Project Name & Address: 401-409 S Baldwin Street & 1303-1323 Williamson Street

Application Type(s): Certificate of Appropriateness for demolition, new construction, and a land combination in the Third Lake Ridge historic district

Prepared By: Heather Bailey, Preservation Planner, Planning Division

Date Prepared: June 21, 2022

1300 block of Williamson, 1908 Sanborn

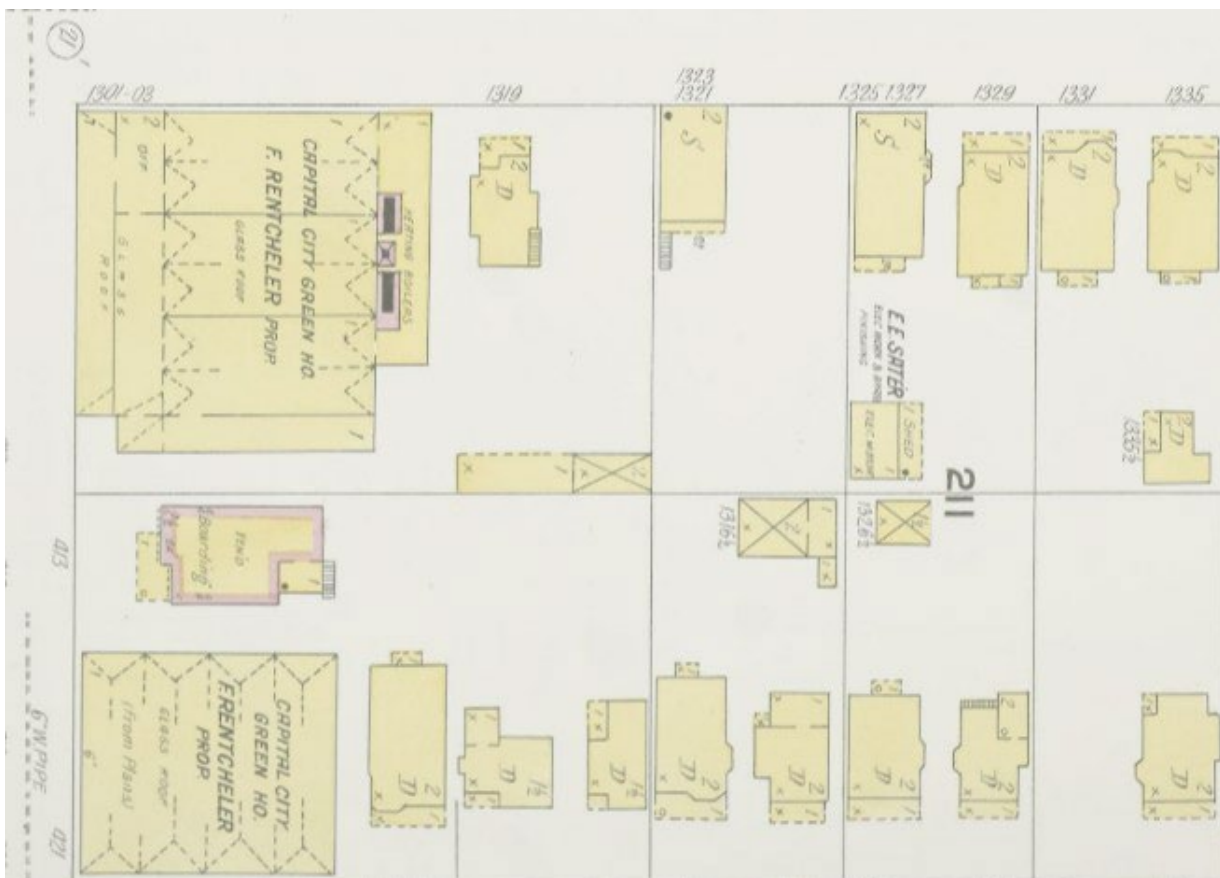
Historically, this area contained structures for a historic greenhouse operation, where the lots at the end of the block were unusually large in order to contain the buildings related to that operation.
